RE: Docket No. 50-220  
I.E. Bulletin 79-02

Your March 8, 1979 I.E. Bulletin 79-02 addressed concerns with pipe support base plate designs using concrete expansion anchor bolts.

NIAGARA MOHAWK POWER CORP  
 SYRACUSE, N.Y.  
 NINE MILE POINT-UNIT#1  
 NRC BULLETIN 79.02

FIGURE 1

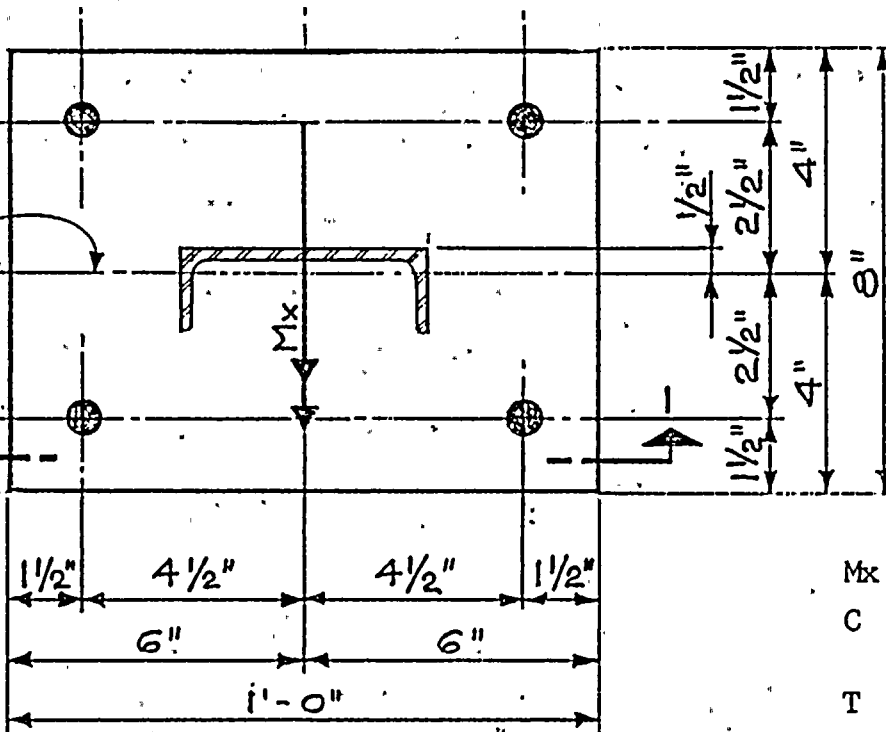
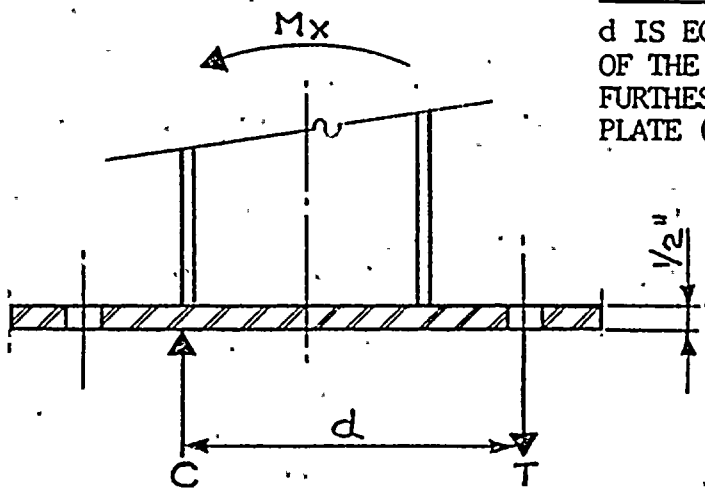
Verify that pipe support base plate flexibility was accounted for in the calculation of anchor bolt loads. In lieu of supporting analysis justifying the assumption of rigidity, the base plates should be considered flexible if the unstiffened distance between the member welded to the plate and the edge of the base plate is greater than twice the thickness of the plate. It is recognized that this criterion is conservative. Less conservative acceptance criteria must be justified and the justification submitted as part of the response to the Bulletin. If the base plate is determined to be flexible, then recalculate the bolt loads using an appropriate analysis. If possible, this is to be done prior to testing of anchor bolts. These calculated bolt loads are referred to hereafter as the bolt design loads. A description of the analytical model used to verify the pipe support base plate flexibility is accounted for in the calculation of anchor bolt loads is to be submitted with your response to the Bulletin.

*For flexibility effects due to the moment, the resultant of the concrete compressive stress was assumed to be acting directly beneath the edge of the attachment which is furthest from the center of the anchors under tension (See Figure 1). This assumption is considered conservative because:*

- 1) *The deflection and resulting load is greatest beneath the point of application of the load.*
- 2) *The attachment to the base plate serves as a stiffener on the base plate. This enables the assumption of rigid plate behavior over that area of the base plate where the attachment is connected.*

d IS EQUAL TO THE DISTANCE FROM THE CENTERLINE OF THE TENSION CONCRETE EXPANSION ANCHORS TO THE FURTHEST EDGE OF THE ATTACHMENT TO THE BASE PLATE (IN THIS EXAMPLE, d = 5.5").

$$\sum m = 0 \text{ IMPLYING } T = M_x/d$$

$$\sum F_y = 0 \text{ IMPLYING } T = C$$
